**Design Addendum**

For Reselton Properties

This Design Addendum has been prepared in direct response to a series of comments provided by London Borough of Richmond Upon Thames regarding the submitted proposals for the former Stag Brewery site in Mortlake.

Block 4 (Maltings) - revised north elevation

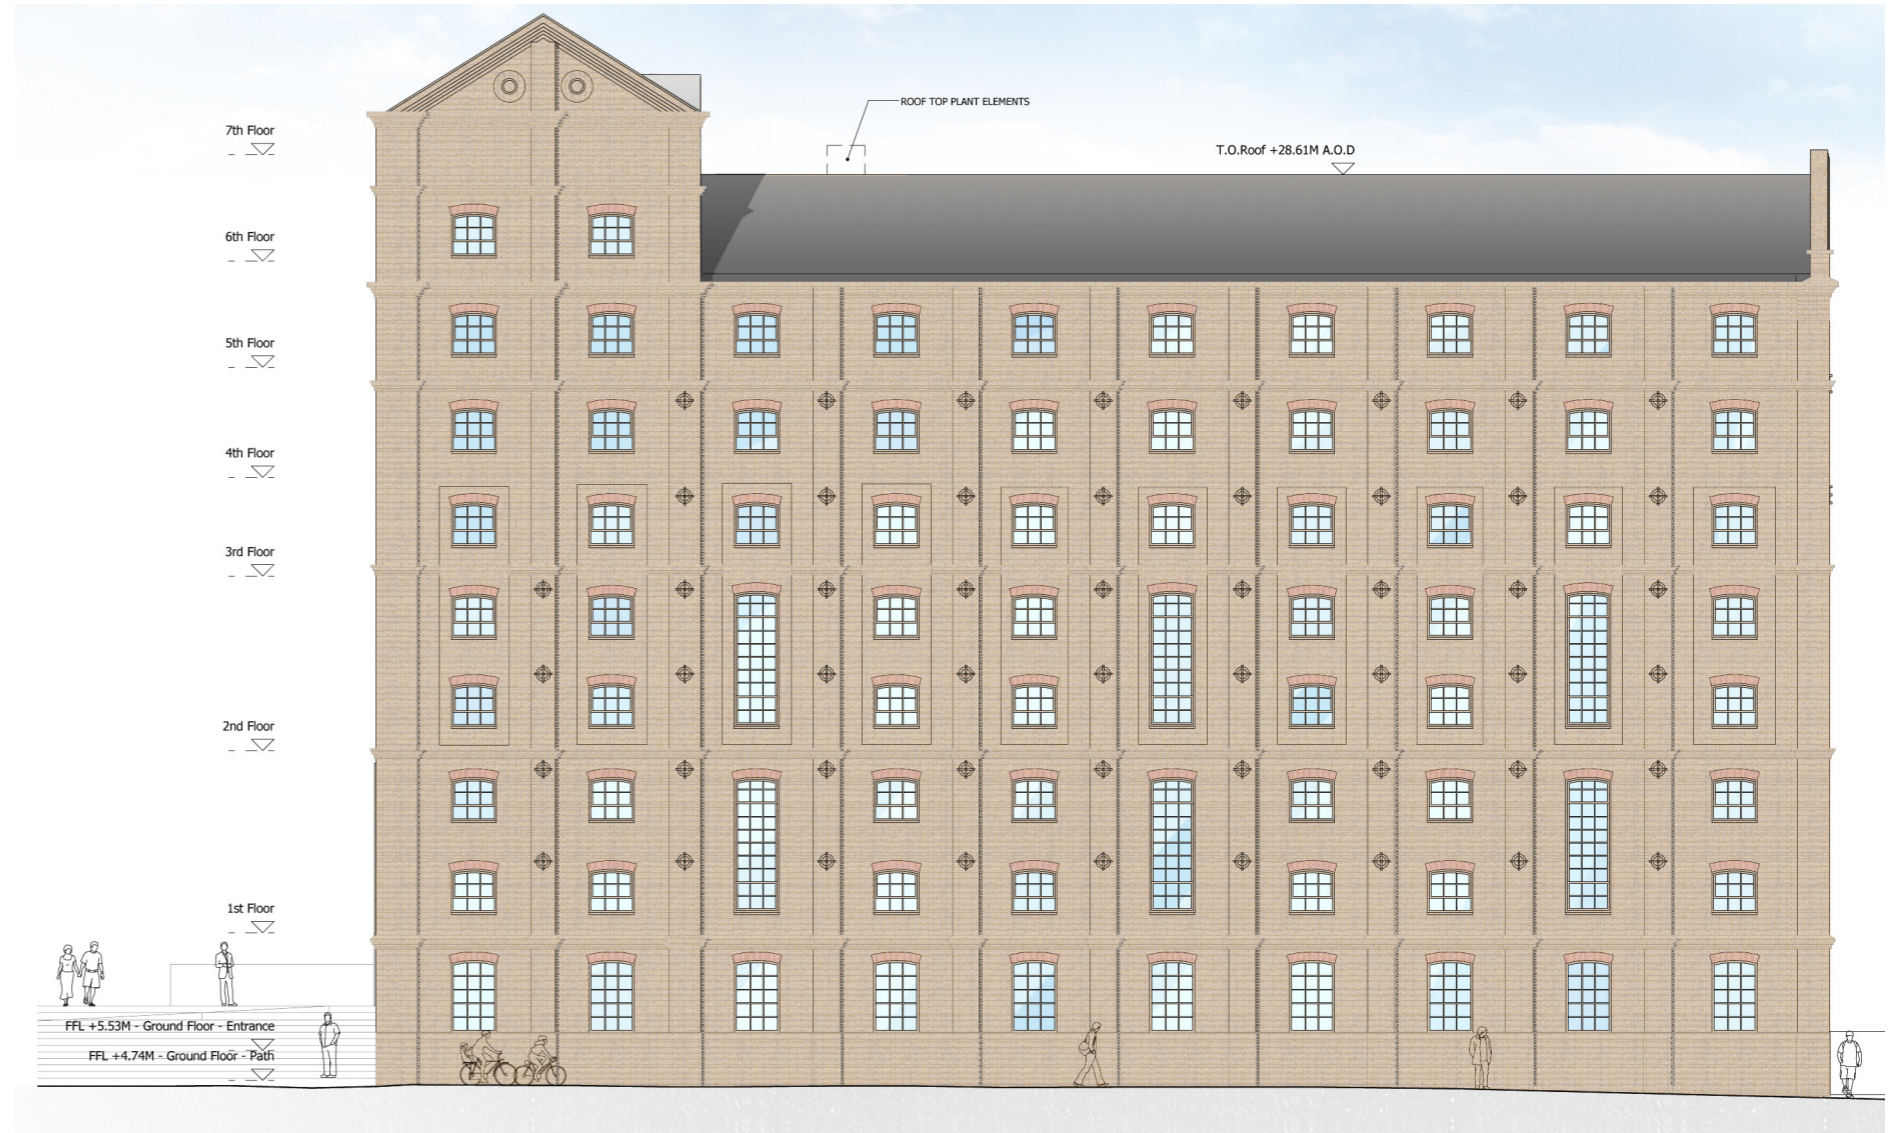
3. Remove Juliette balconies to the double height windows.

The double height windows have been re-designed and balustrades to 'juliette balconies' have been omitted. It is also proposed that existing columns will be re-located within the ground floor entrance area to the community use space. The ground floor plan has been revised to show indicative locations.

Revised east elevation of Hotel

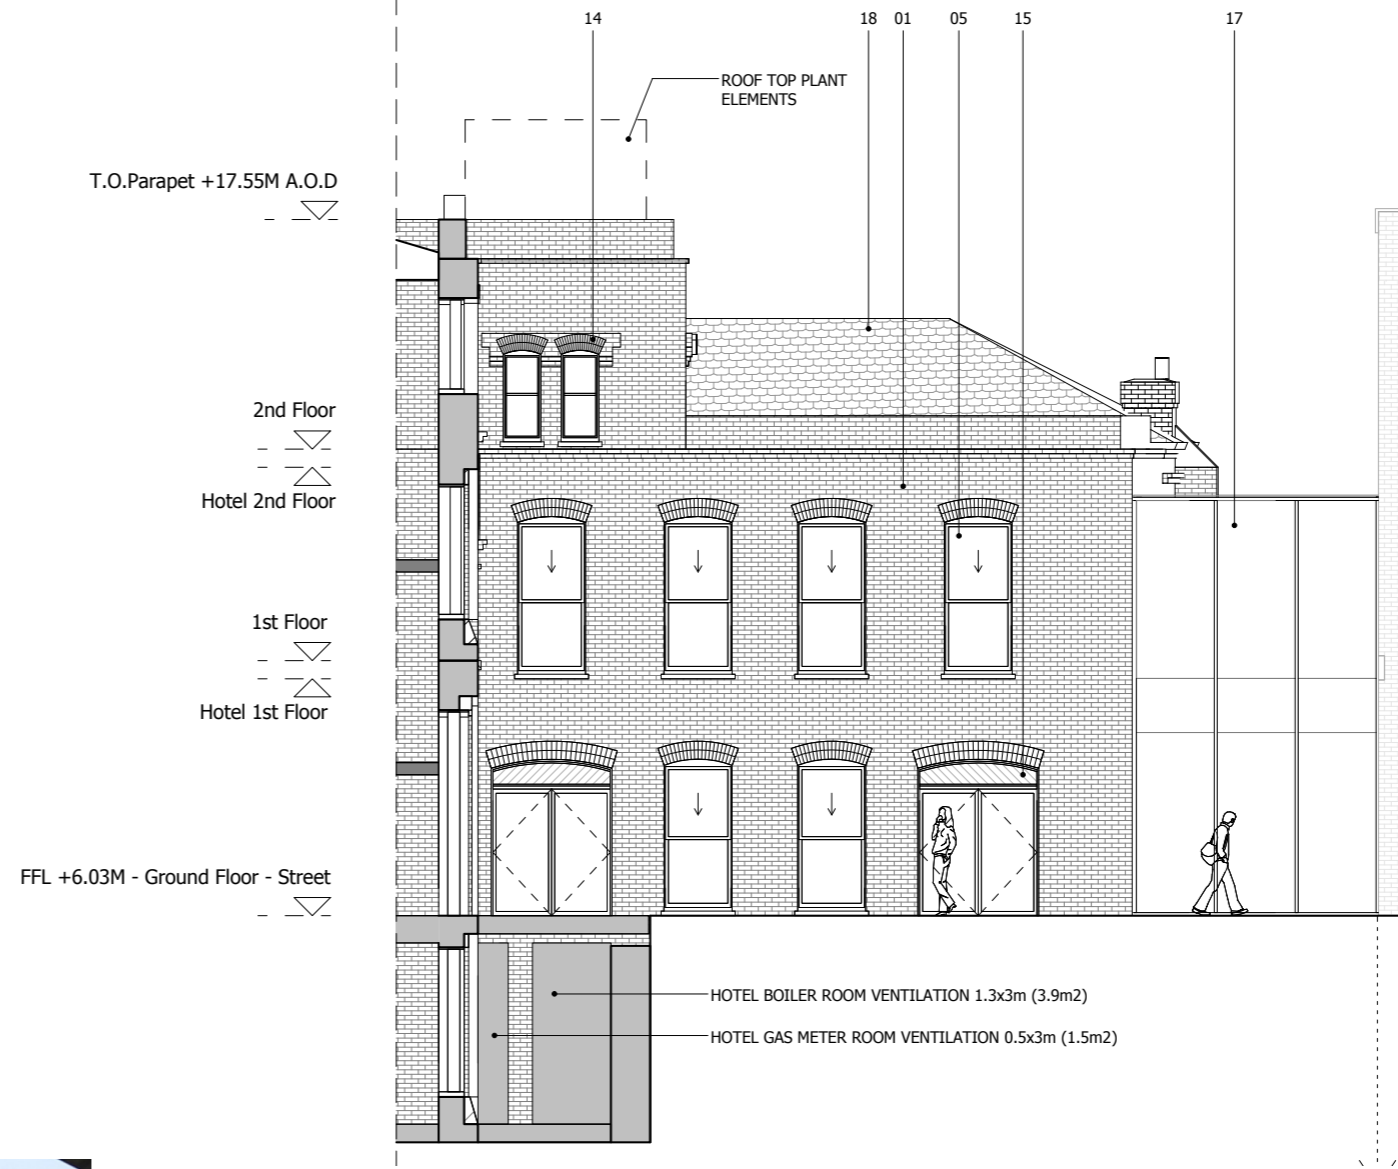
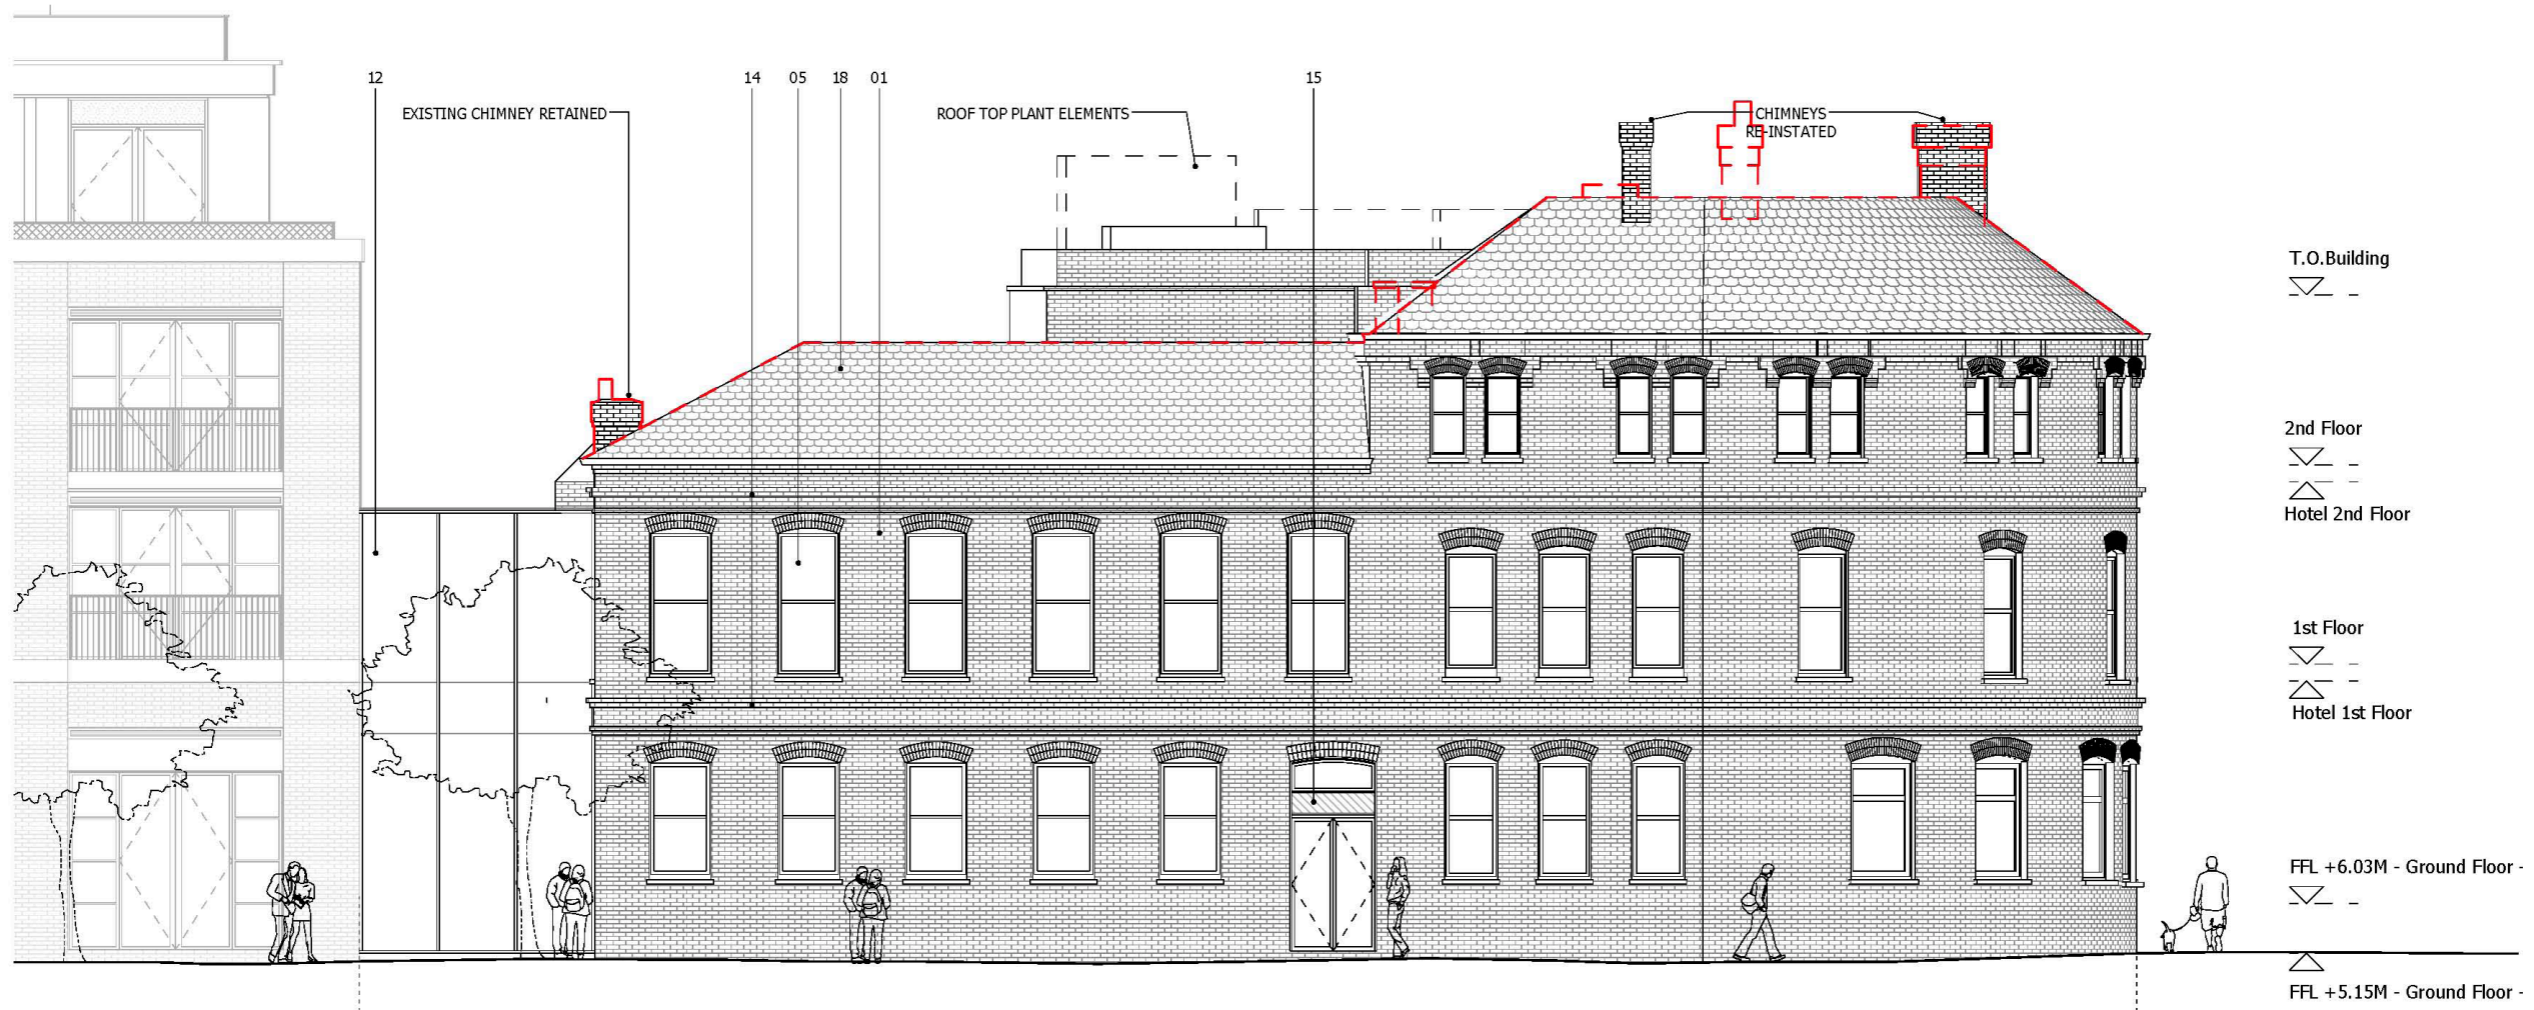
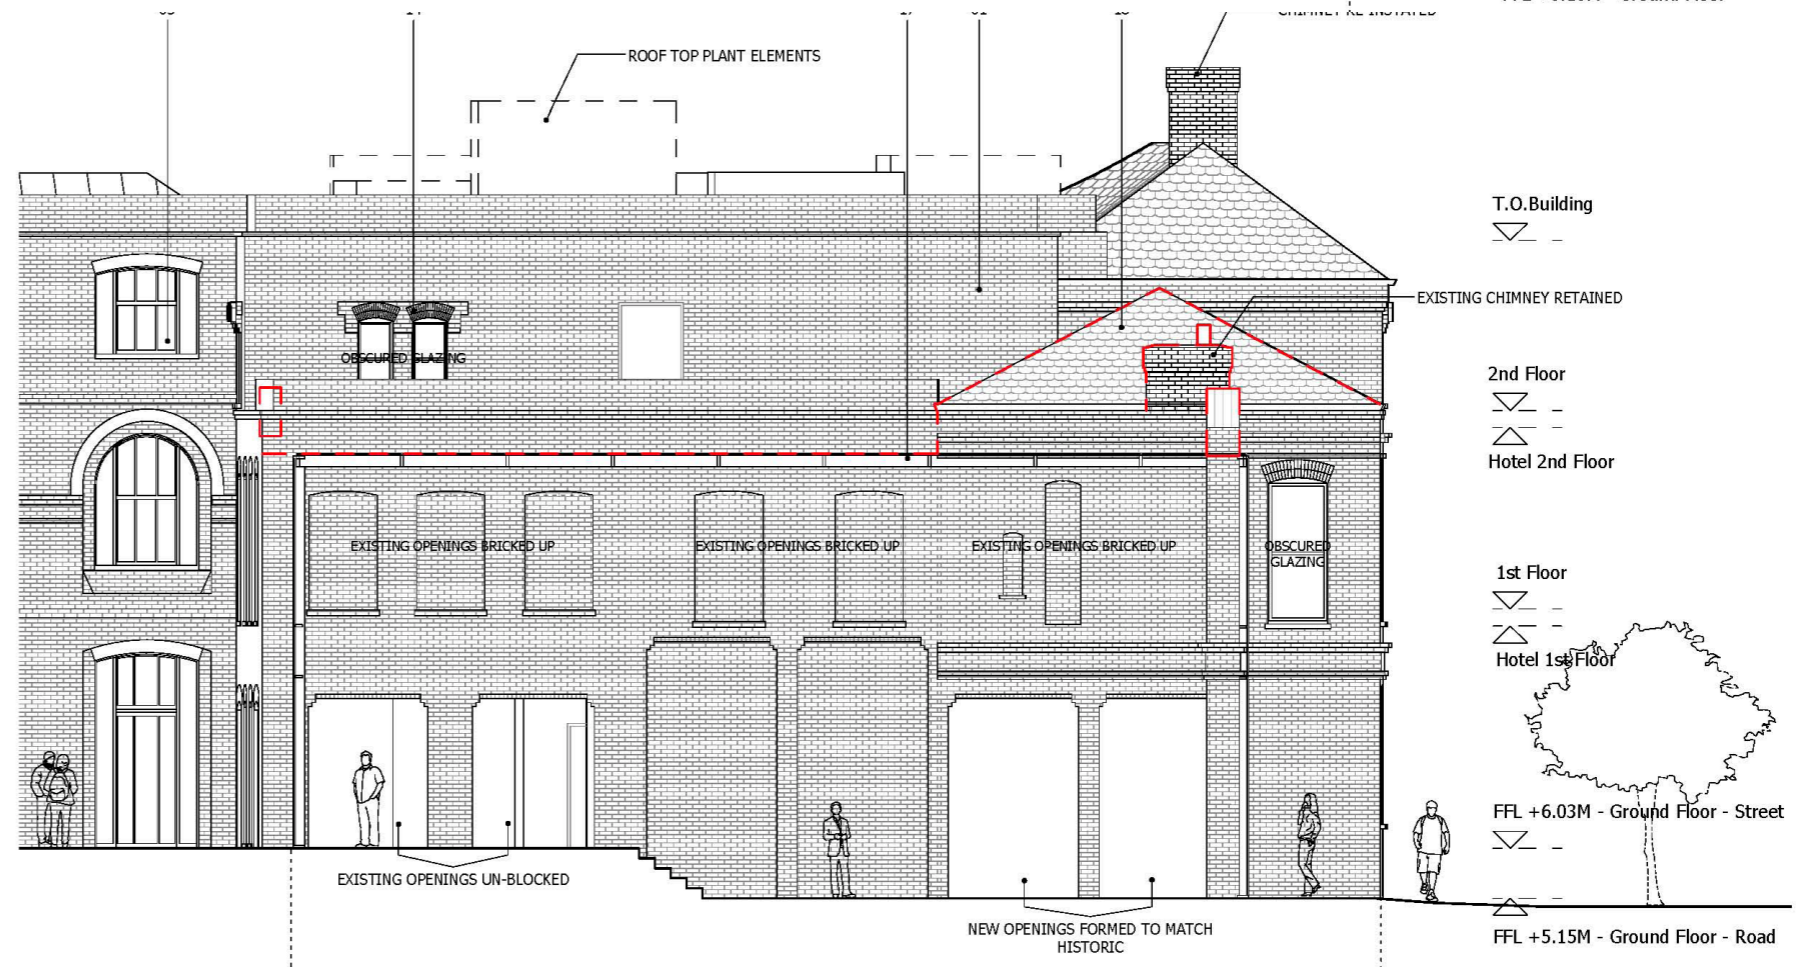
1. North façade of hotel – This building is a BTM in a prominent position. Facades are clearly visible from the public realm and the building forms an important part of the character of this part of the conservation area. The loss of all but the west/south façade represents substantial demolition and harm to BTM with lack of justification. Provide justification for substantial demolition. Must retain front and side facades, the roofline and chimney stacks.

We disagree that the North façade should be retained as opposed to demolished. The existing North façade meets an existing ground level which sits 810mm lower than the proposed new 'Bottleworks Square'. This new level is required due to flood level constraints (the level has been established in order to provide accessible routes that mediate between the existing streetscape and highest levels of flood defence). It is also proposed that a new (deepened) basement level is provided beneath the existing hotel. The combination of these factors make it an unviable solution to retain the north façade as part of the proposal for the hotel.

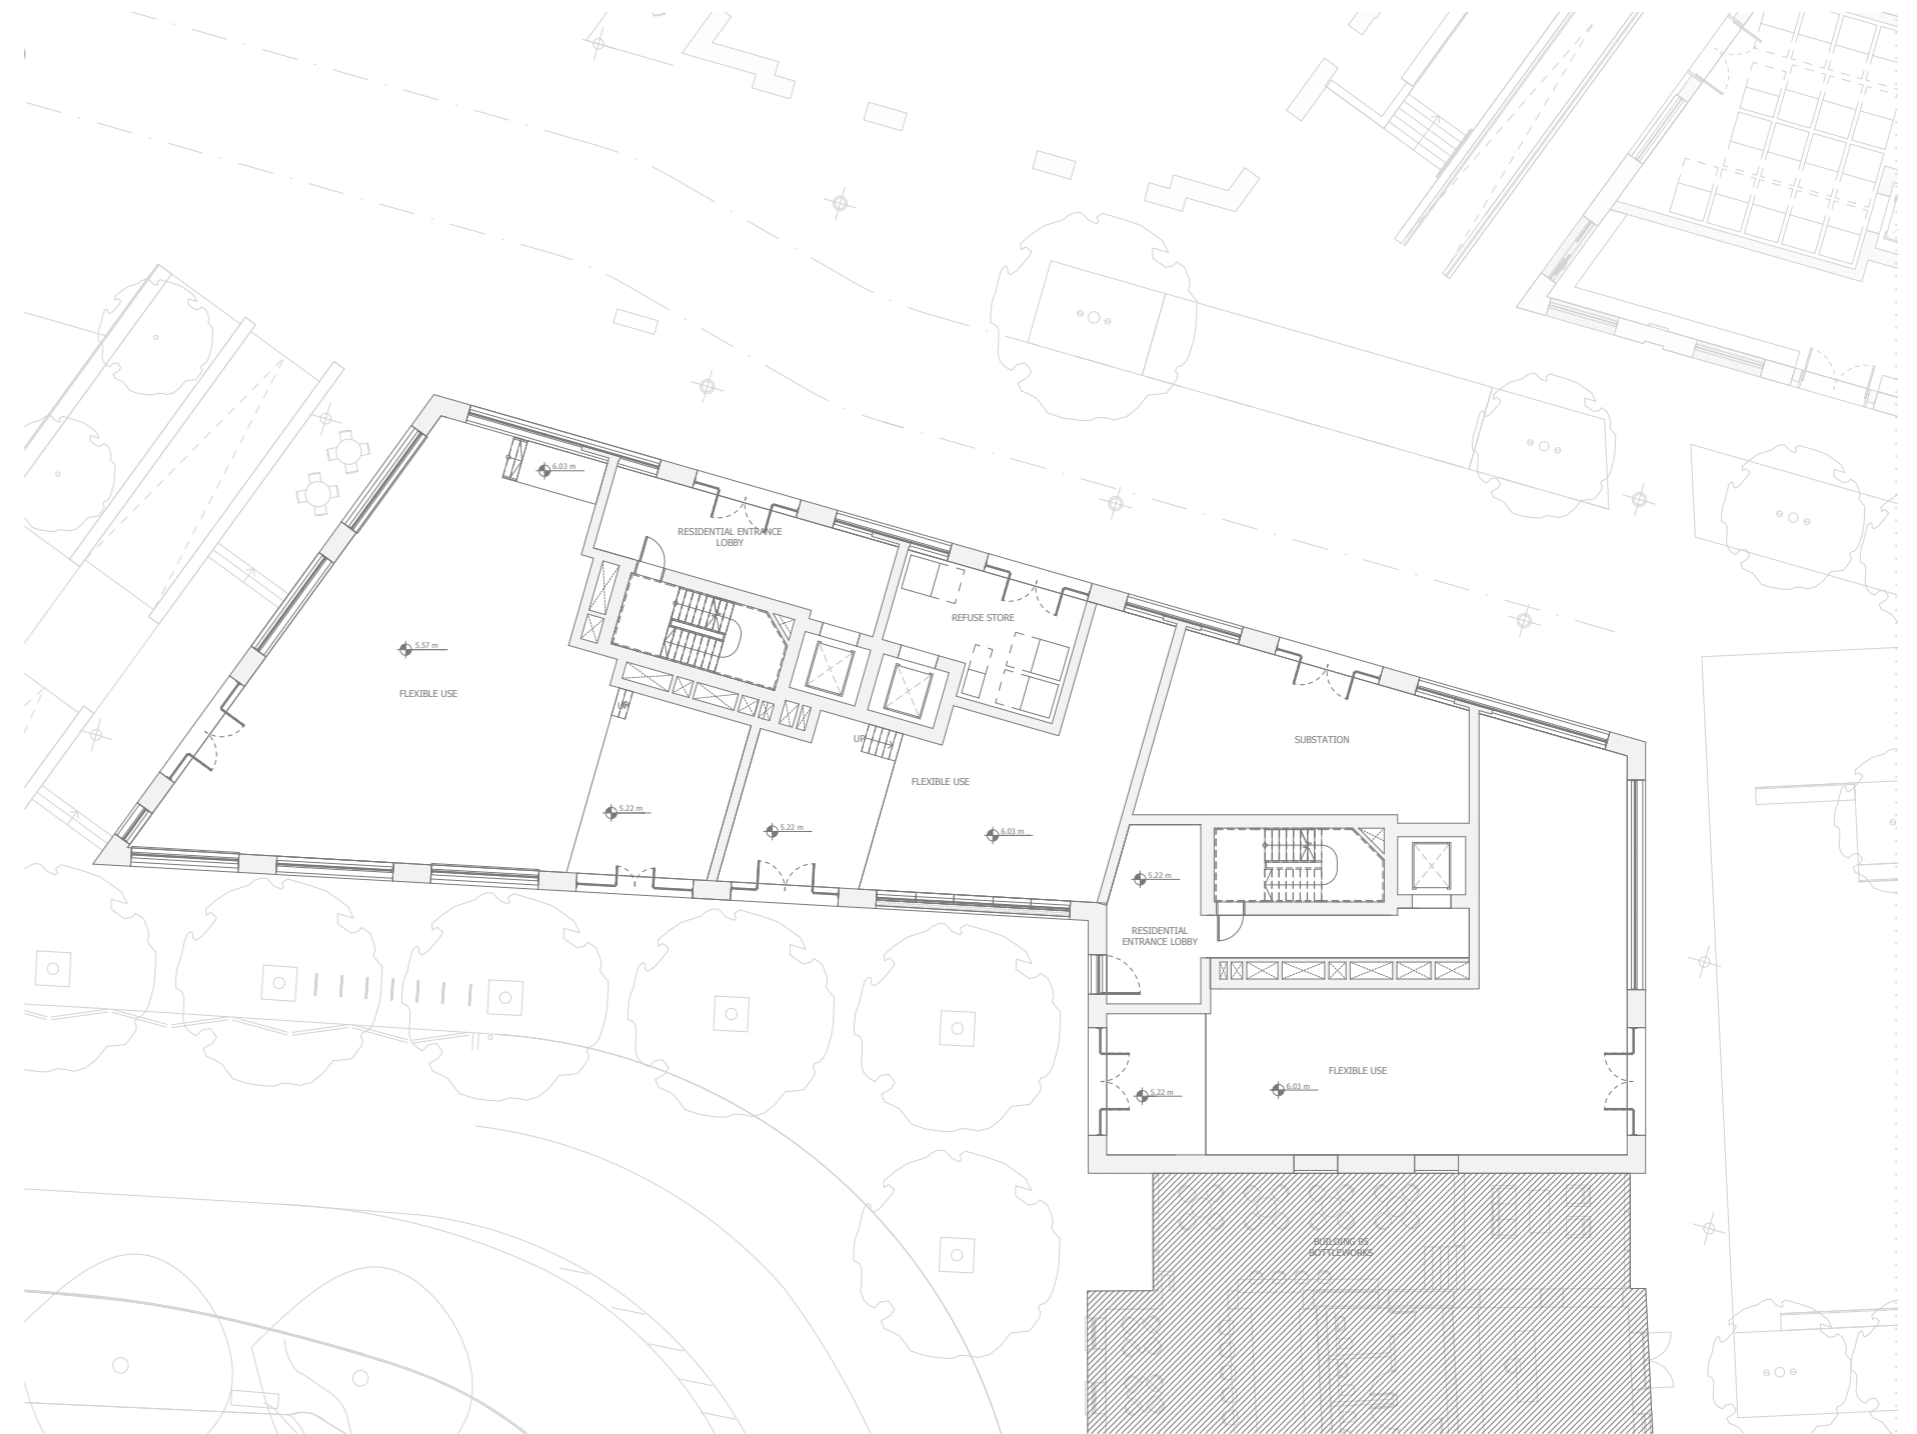
10. Remove glazed balustrade at roof level.

The roof level balustrade was proposed as a means of edge protection (from risk of falls) to any maintenance personnel when accessing roof top plant. We would not recommend removing this balustrade since this would pose a health and safety risk.
